**TOWN OF NEWBURGH  
PLANNING BOARD  
TECHNICAL REVIEW COMMENTS**

**PROJECT NAME:** ADS PROPERTIES CAR WASH  
**PROJECT NO.:** 2021-04  
**PROJECT LOCATION:** SECTION 95, BLOCK 1, LOT 14.1  
**REVIEW DATE:** 31 JULY 2025  
**MEETING DATE:** 7 AUGUST 2025  
**PROJECT REPRESENTATIVE:** GNS GROUP

W.1

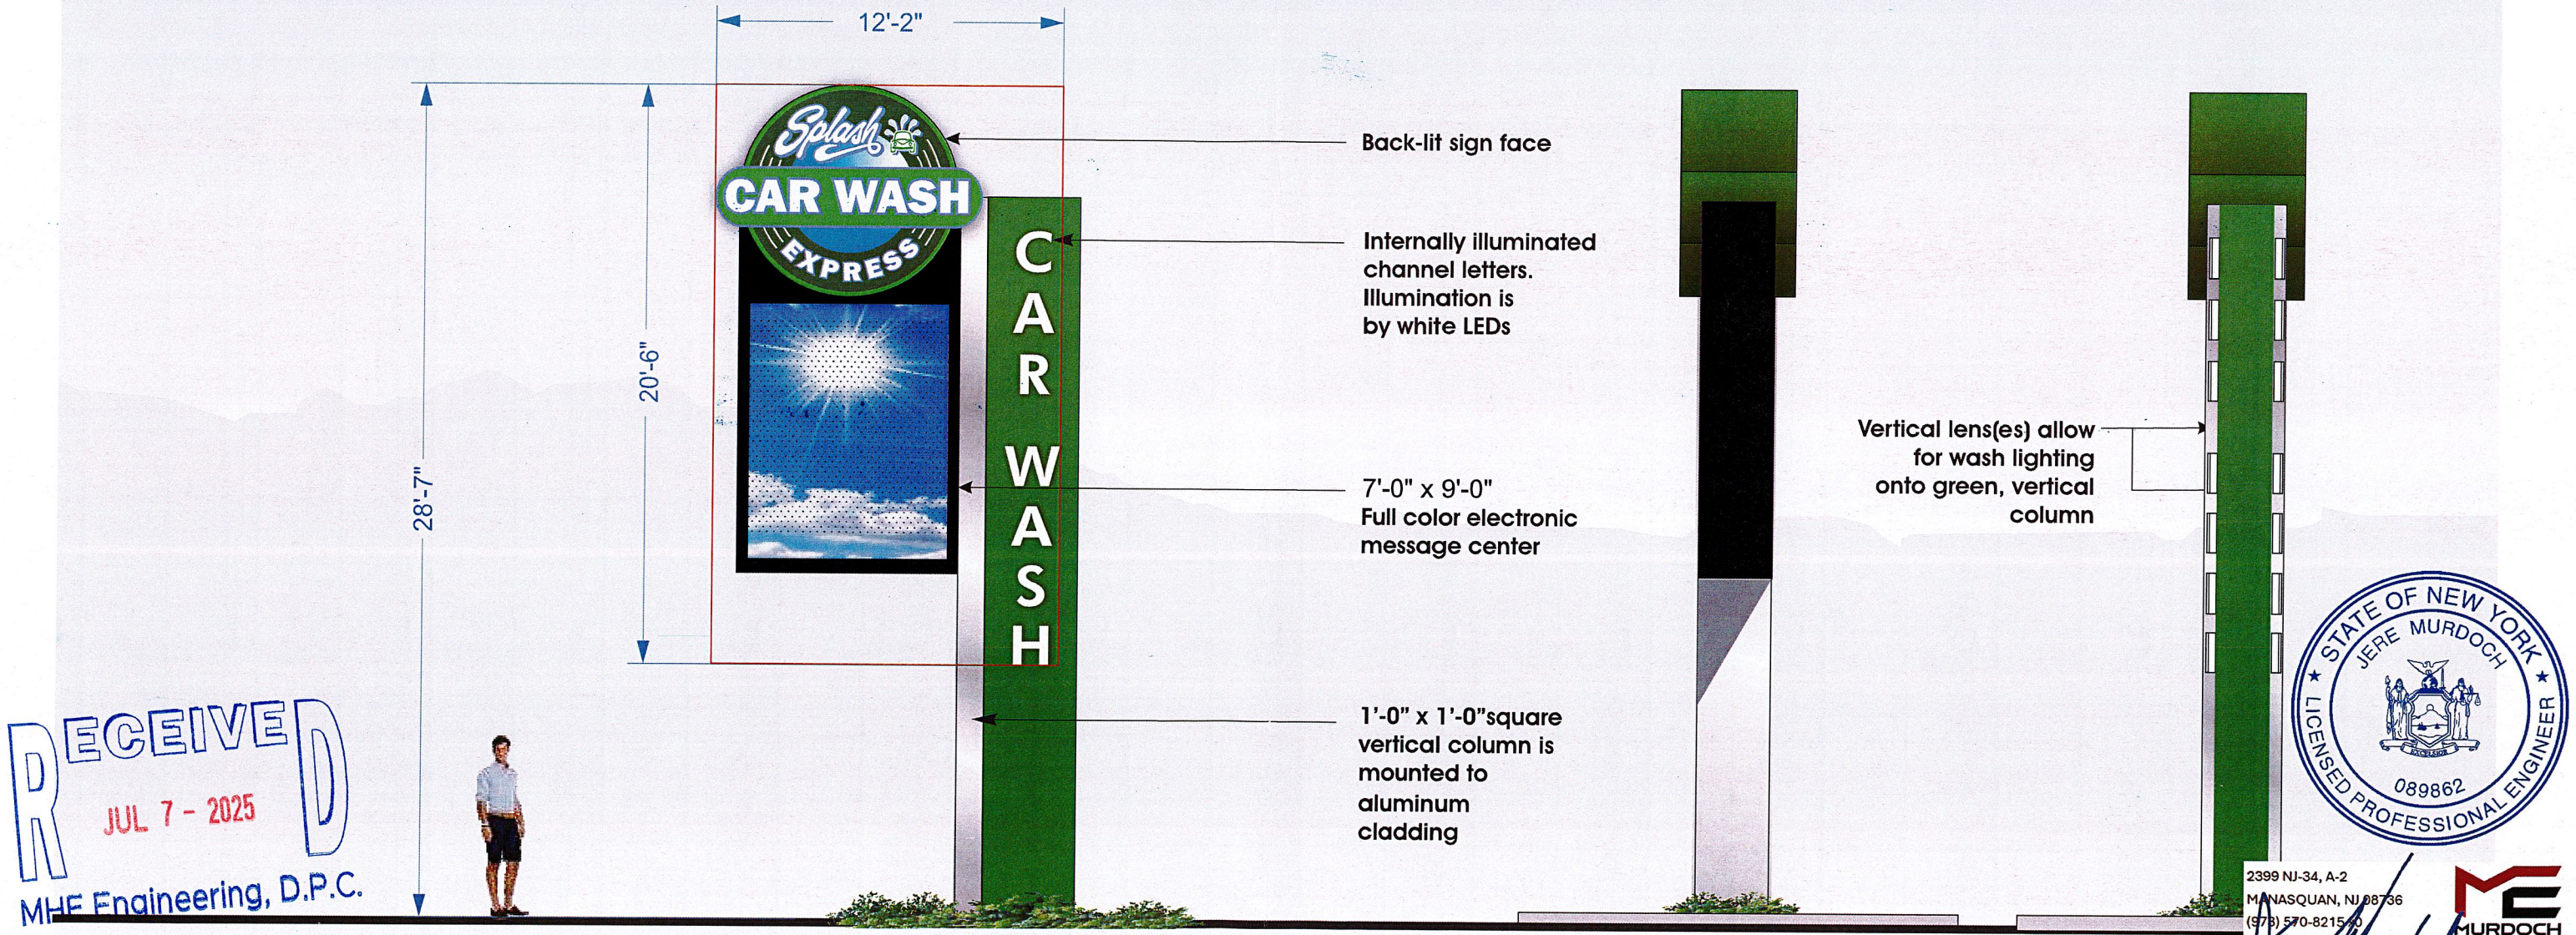
1. The project is before the Board for architectural review and special use permit for an electronic sign on the subject property.
2. Comments from Code Enforcement should be received regarding the sign and compliance with Zoning Code Section 185-14 P.
